Urgent Field Safety Notice

Manufacturer's reference: SB_RDC_2019_05

Important information on the Accu-Chek® Solo micropump system related to a new method to insert the pump into the pump holder in order to avoid insulin leakage

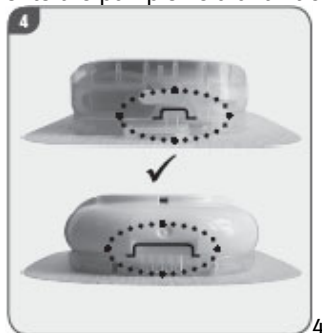
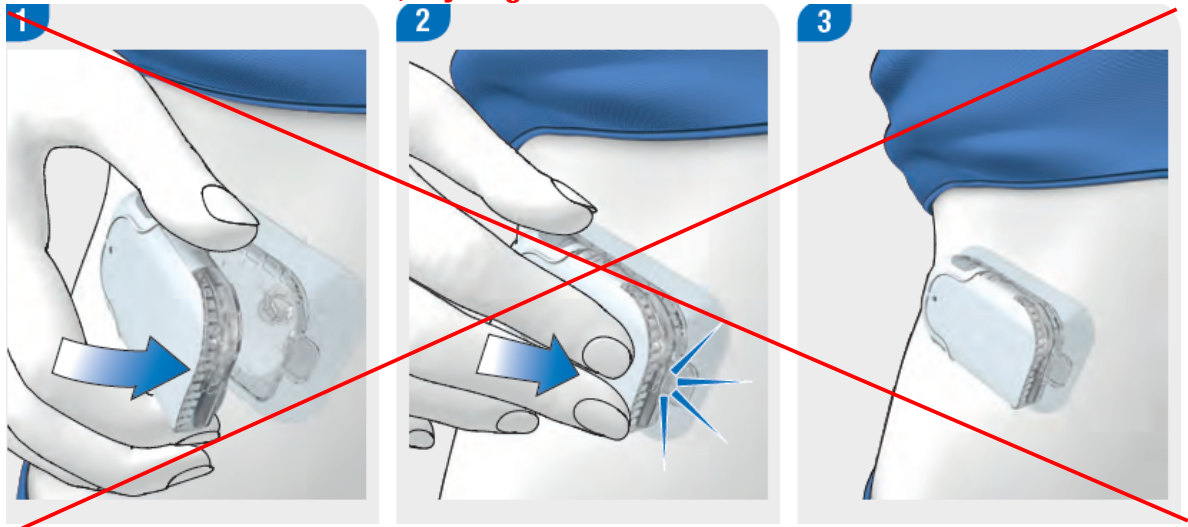
When the customer applies a side load on the Accu-Chek® Solo micropump when inserting the pump into the pump holder, insulin leakage at the septum of the cannula assembly could occur because of an improper penetration of the septum of the cannula assembly by the connecting needle. This may lead to high blood glucose values and potentially to severe hyperglycaemia up to diabetic ketoacidosis (DKA) with a serious outcome.

From now on, patients should only use the new **turn-in method** for inserting the Accu-Chek® Solo micropump into the pump holder following the procedure described below:

1 Place the reservoir needle on the grey cannula head of the pump holder.

2 Place the reservoir needle of the micropump on the grey cannula head of the pump holder.

3 Turn the micropump carefully into place. After a quarter turn, the micropump clicks into the front hooks on the pump holder.

4 Make sure the micropump engages properly with the front and back hooks on the pump holder. If not, press onto the pump shield until it clicks into the pump holder.

Users should not apply too much force when attaching the micropump, because the septum between the pump and the cannula assembly may become damaged and, as a consequence, insulin leakage can occur. This may lead to an insufficient supply of insulin.
